RUSSIAN FEDERATION MINISTRY OF TRANSPORT OF THE RUSSIAN FEDERATION FEDERAL AIR TRANSPORT AGENCY AIRWORTHINESS DIRECTIVE

No. 2023-AHCAT, AHCAT-CK-06

Applicability – ANSAT helicopters (ANSAT, ANSAT-GC model)

TECHNICAL DECISION No.3/144-2023-KB3

Fig. 1

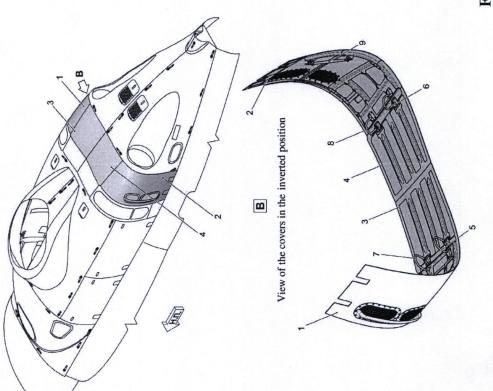
1. When carrying out periodic technical maintenance within the scope of "50 flight hours // 12 calendar months" maintenance form, inspect the inside of the rear cowling panels 334.6930.200-01 (-02) (pos. 1, 2, Fig. 1, Appendix 1), the inside of the gas generator compartment covers 334.6931.500-01 (-02) (pos. 3, 4, Fig. 1, Appendix 1), the hinges 333.6930.020-01 (-02) and 333.6930.030-01 (-02) (pos. 5, 6, 7, 8, Fig. 1, Appendix 1) for presence of paint coating, as well as for presence of ЦИАТИМ-201 grease in the area of the hinges connection to the brackets of the rear cowling panels.

In case of detection of paint coating, perform its removal in accordance with the temporary task card 071.10.00e (Appendix 2).

In case of detection of ЦИАТИМ-201 grease in the area of the hinges connection to the brackets of the rear cowling panels, remove it with HEΦPAC solvent, brush and cotton rag.
